S.S. PAPADOPULOS & ASSOCIATES, INC.
ENVIRONMENTAL & WATER-RESOURCE CONSULTANTS

Subject: Sparton Technology, Inc., Former Coors Road Plant Remedial Program Approval of the 2007 and 2008 Annual Reports and of the "Evaluation of Alternative Systems and Technologies for Aquifer Restoration" Report, and Comments on the 2008 Annual Report.

Figure 2.4 Schematic Cross-Section Showing Screened Interval of Monitoring Wells and Relation to Flow Zones

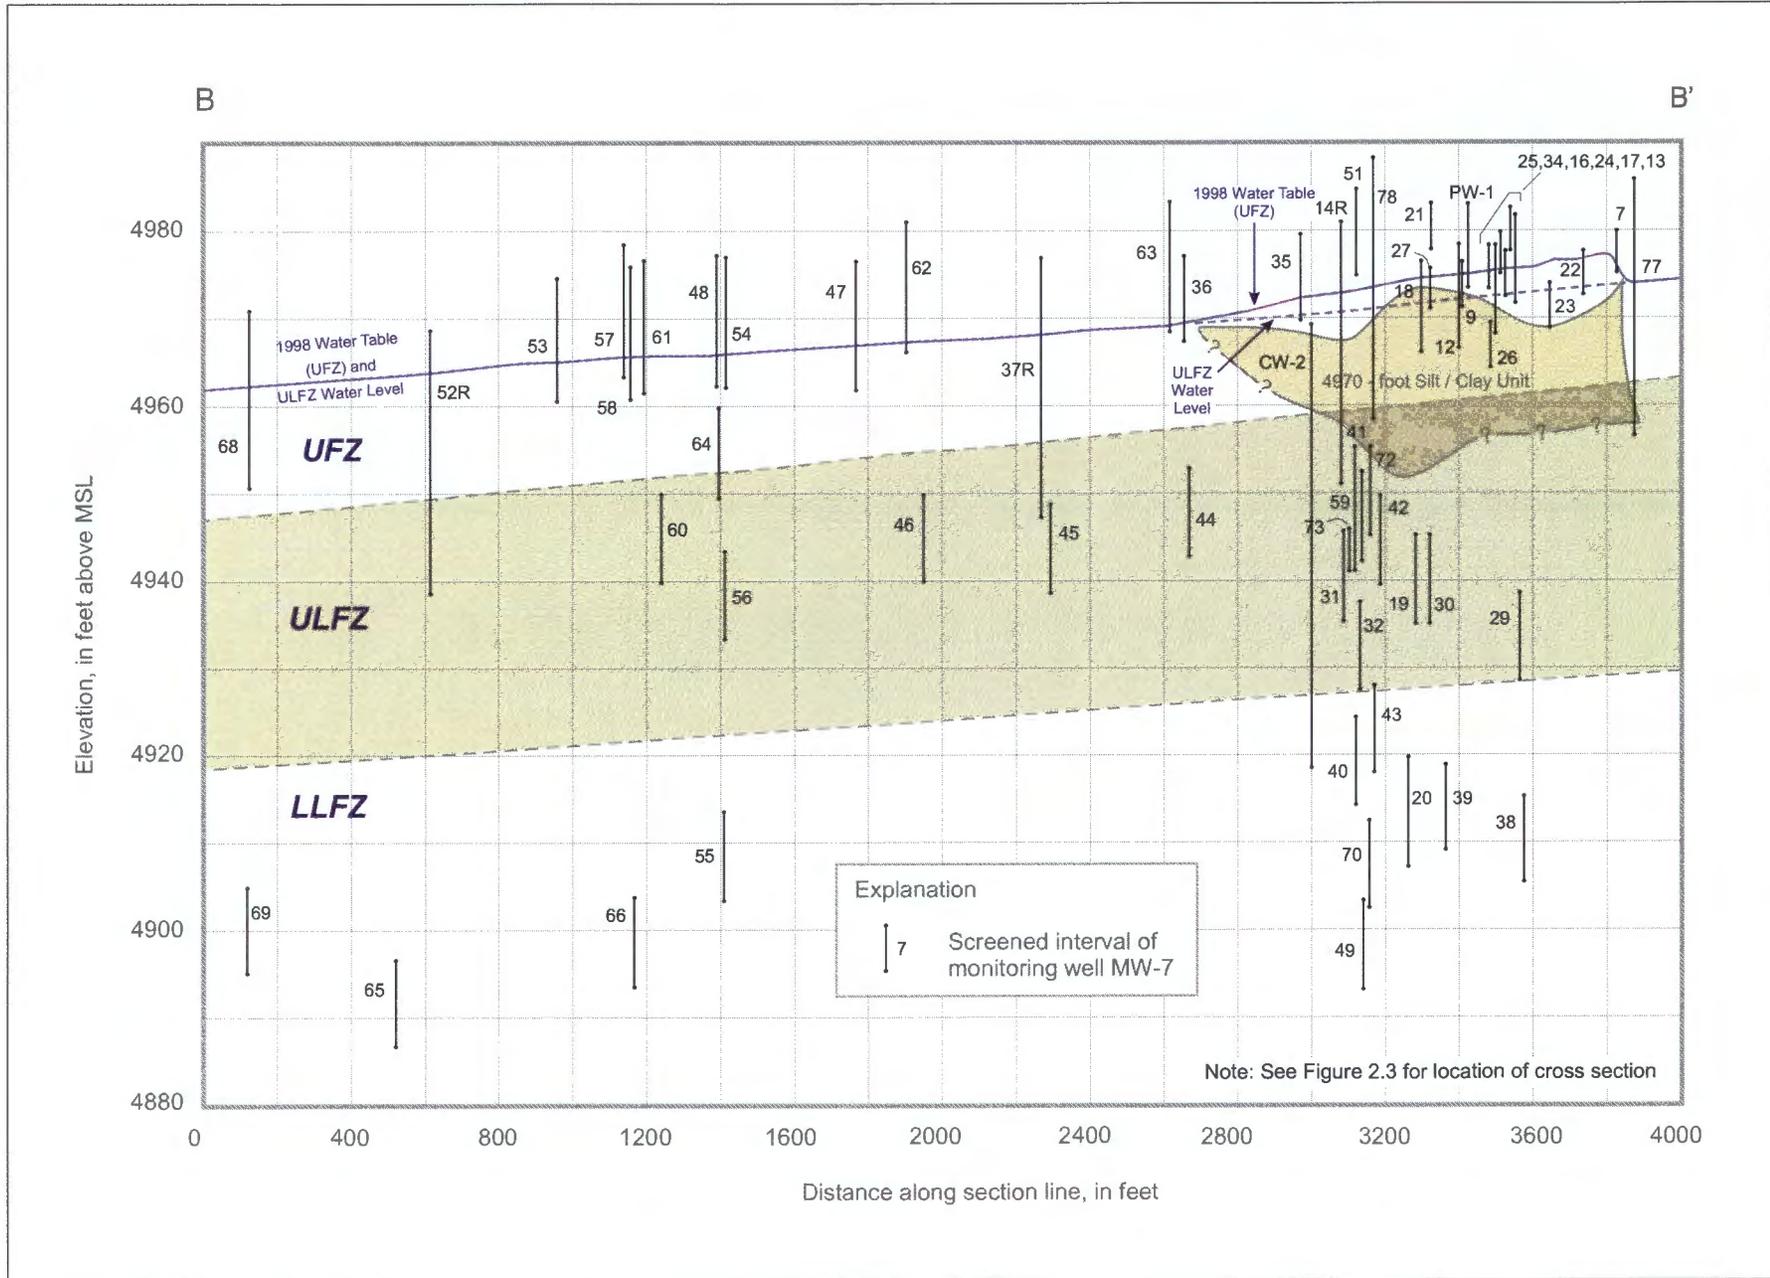
8. Figure 2.4: Please label the water table as the 1998 water table.

A corrected Figure 2.4 is attached.

Figure 5.18 Horizontal Extent of TCE Plume - November 2008

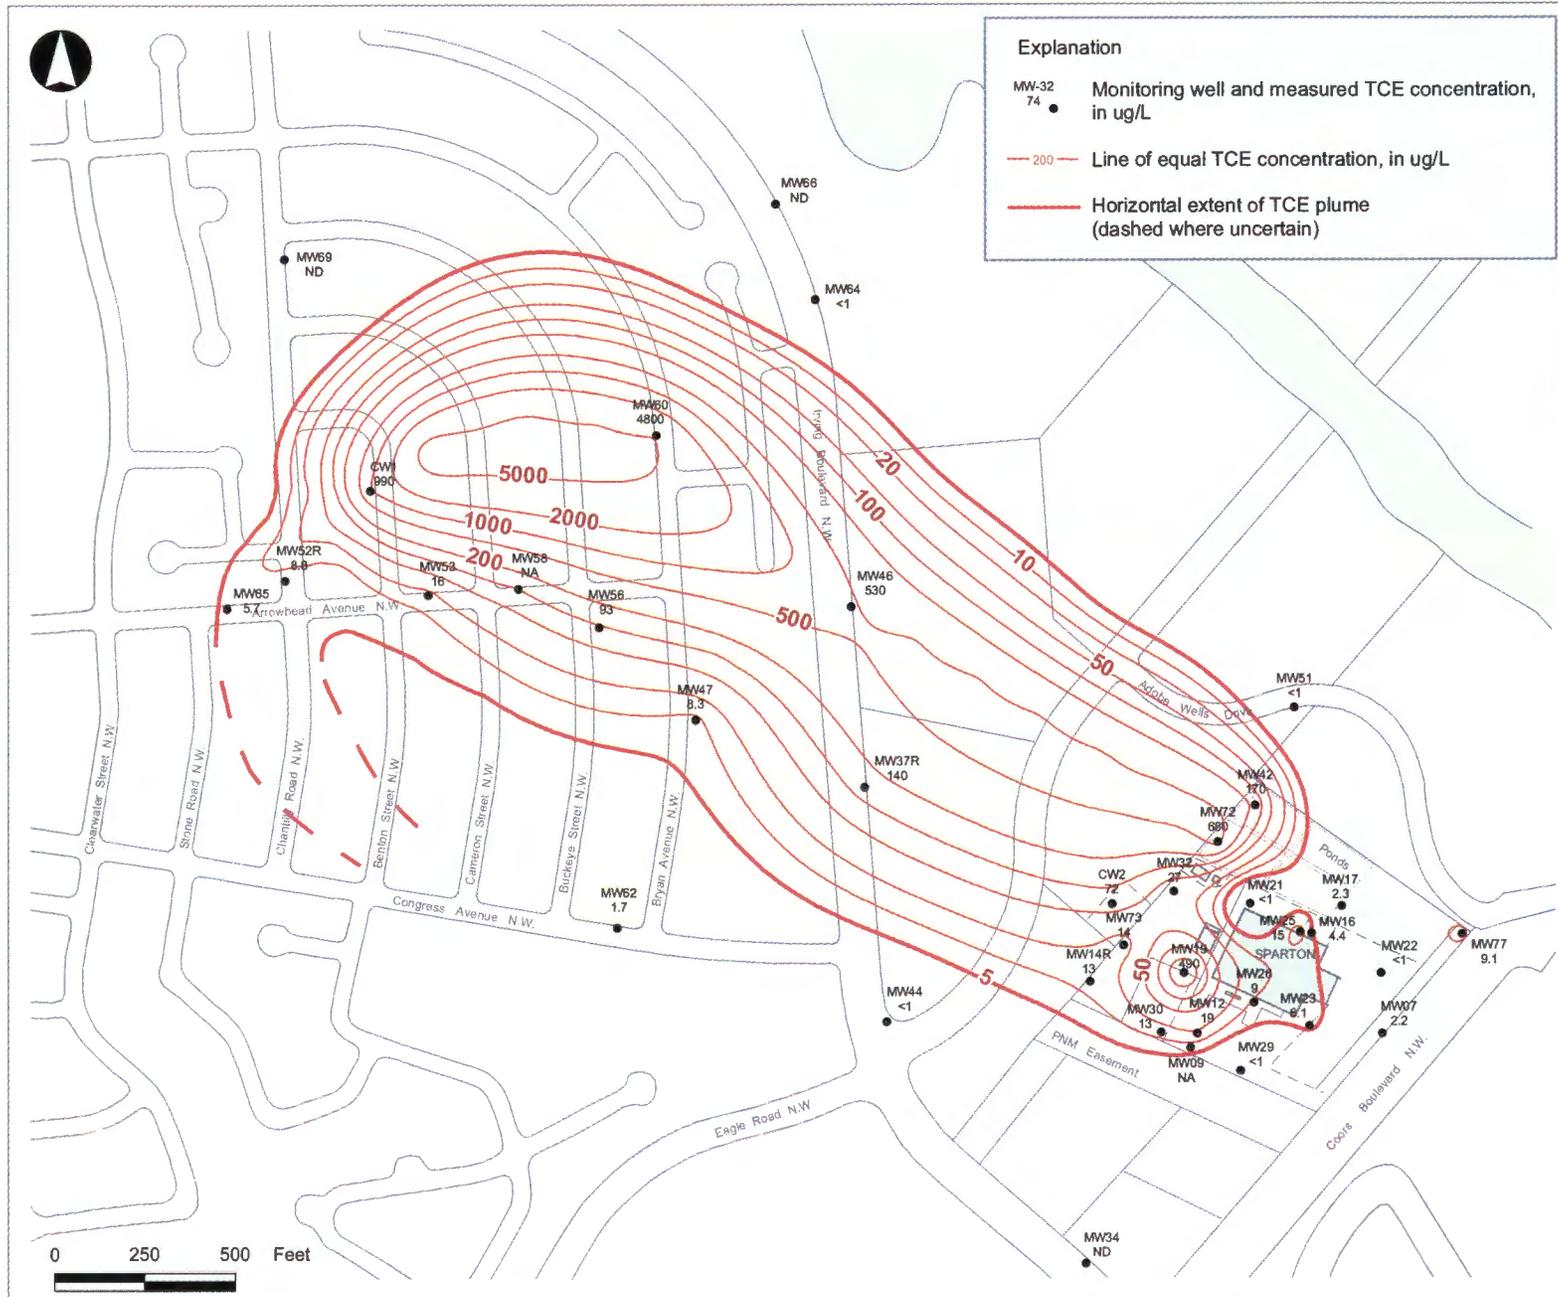
9. Plume boundary: Sparton presented a new plume boundary on figures following Figure 5.9, apparently intended to depict a separate plume, with a DCE-dominated signature, flowing through the location of Well-65. This depiction constricts the plumes too much: it excludes MW-52R, a mixed-signature well, from the TCE plume and does not include MW-62, a DCE-dominated well, in the DCE-dominated plume. The plume boundary lines should be expanded at least as much as necessary to fit these wells into their plumes, with consideration of flow paths and contaminant histories.

Well MW-52R is not excluded from the boundary of the 2008 TCE plume (Figure 5.18), it is within this boundary; however, the boundary of the TCE plume (defined by the 5 µg/L contour) was slightly modified to the east of this well to reflect that the well is affected by both the main TCE-dominated plume and the separate DCE-dominated plume. The modified Figure 5.18 is attached. Also attached are Figures 5.10, 5.11, and 5.12 which have been revised using the modified boundary of the 2008 TCE plume.

Figure 5.13 Schematic Cross-Sections Showing November 1998 and 2008 Water Levels and Containment Well Capture Zones

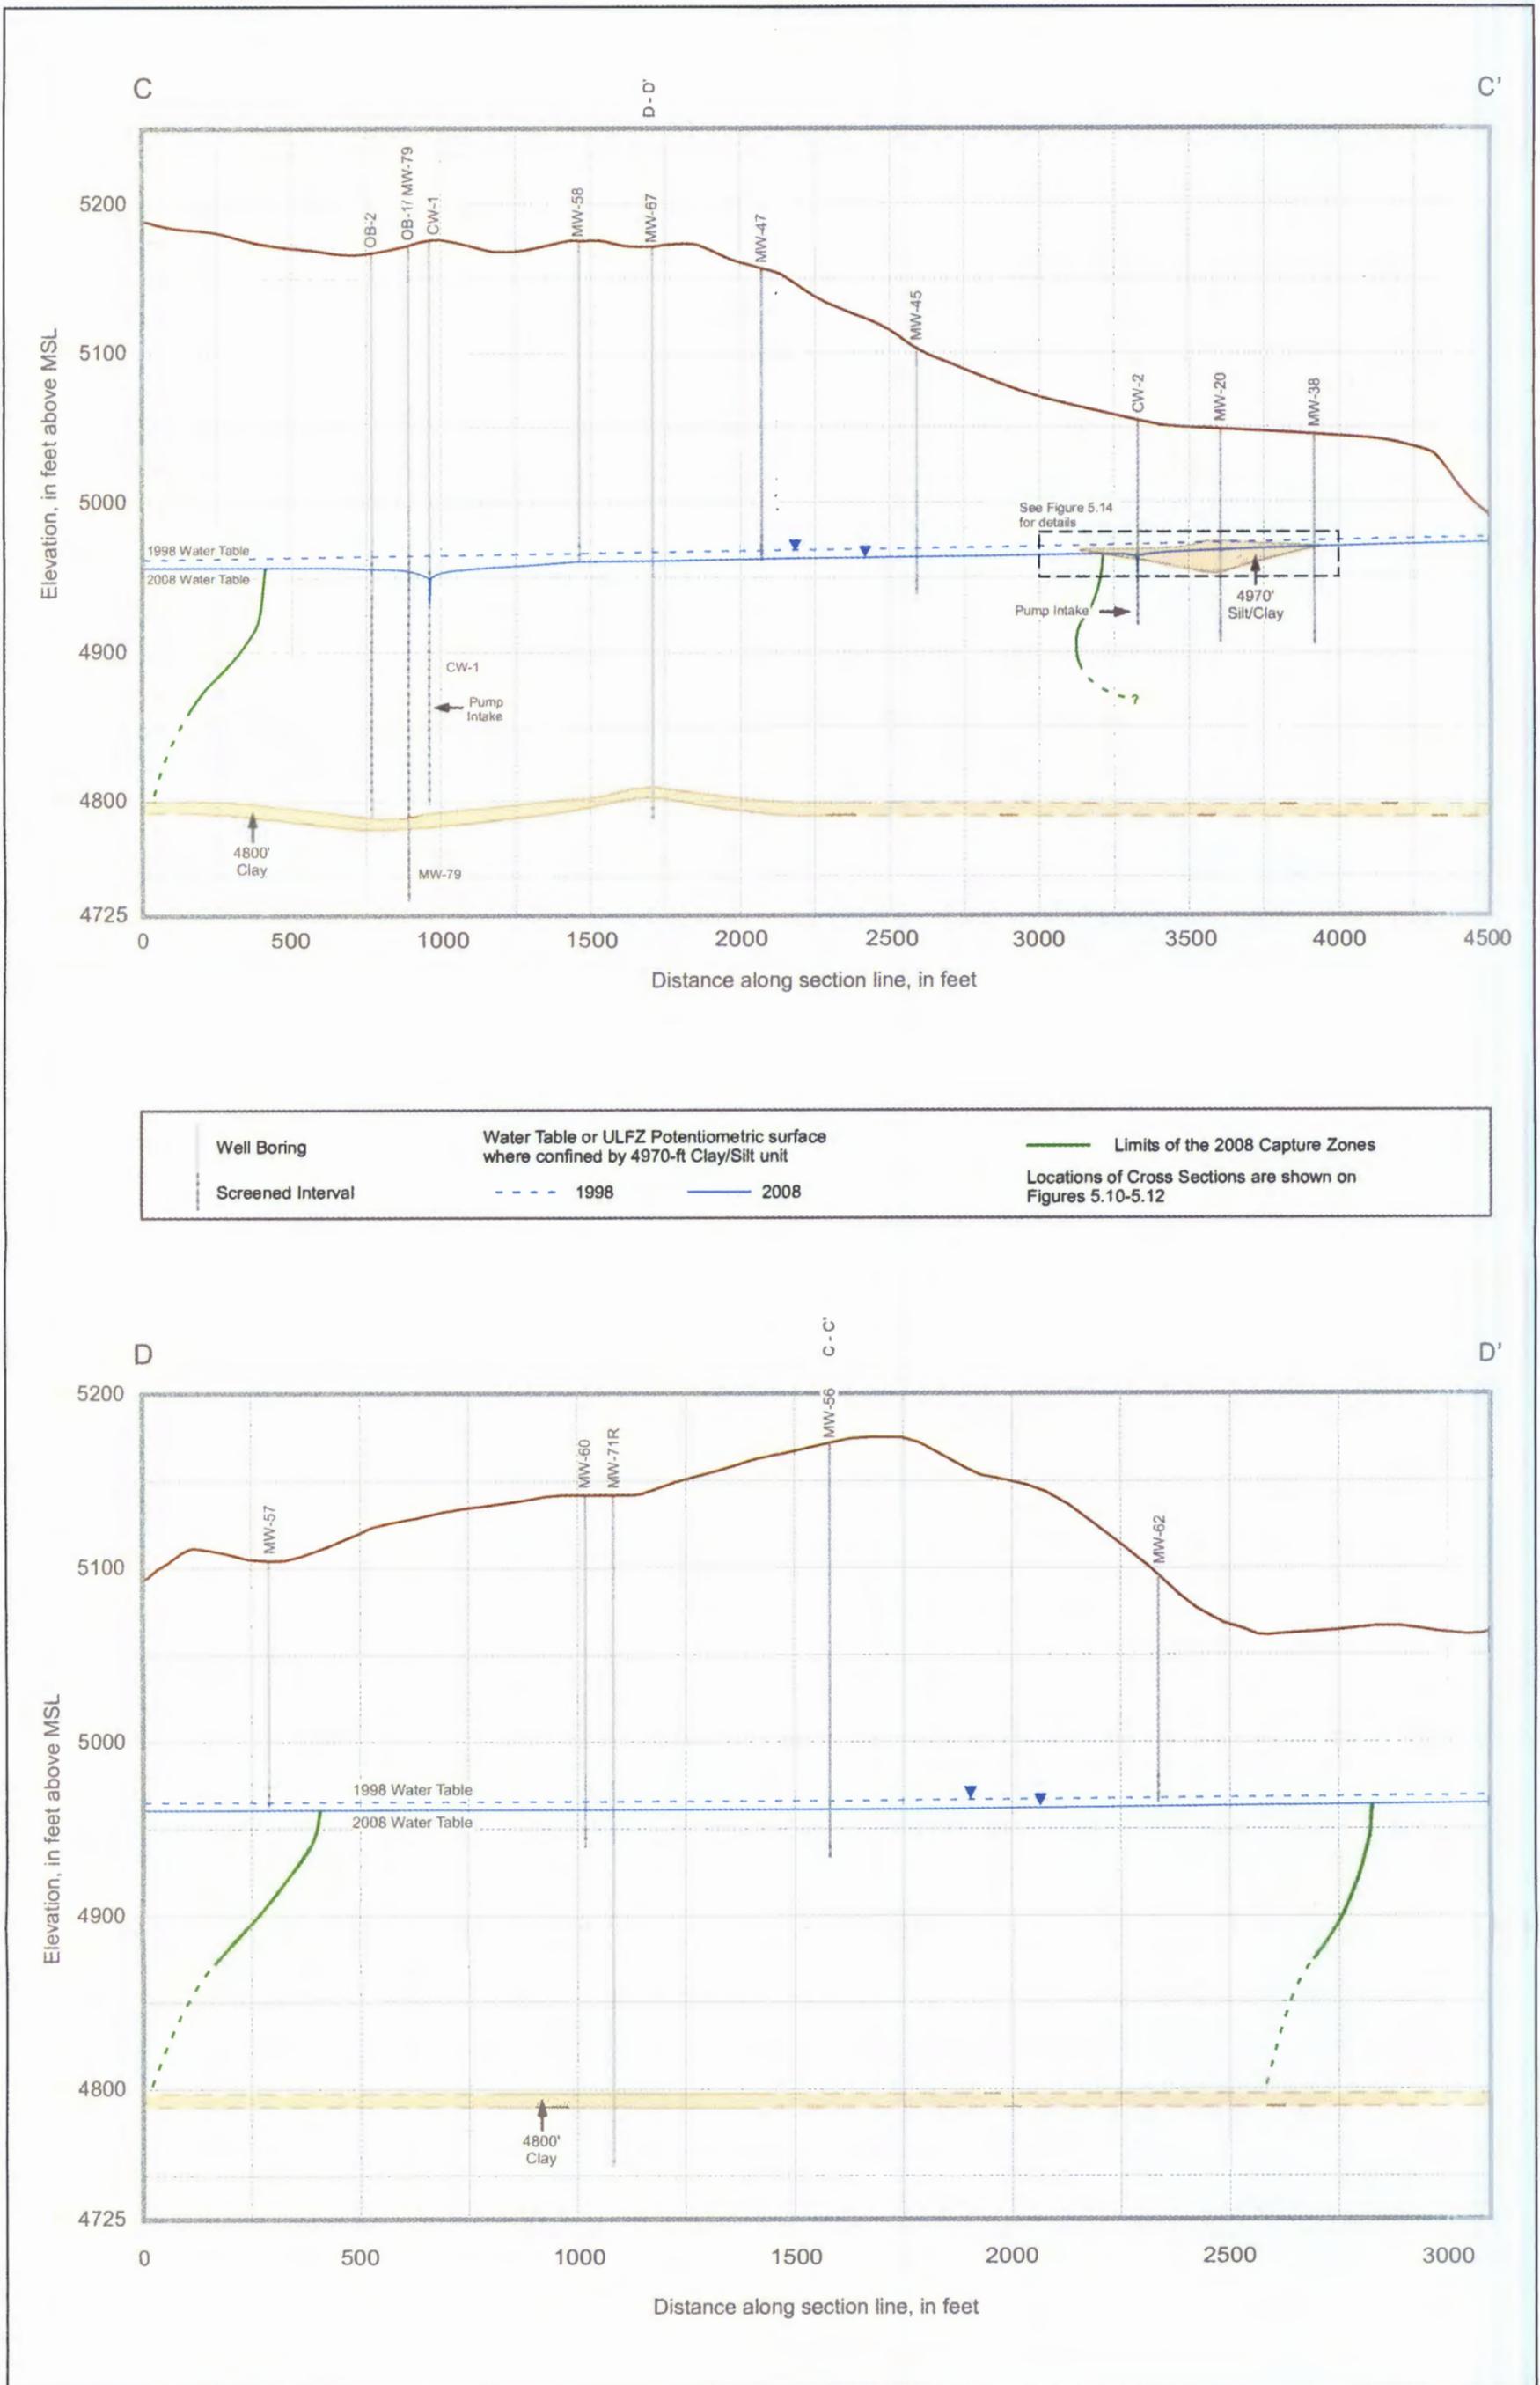
10. Figure 5.13: The Pump Intake label should be moved from OB-2 to CW-1, with the arrow at the pump elevation.

A corrected Figure 5.13 is attached.
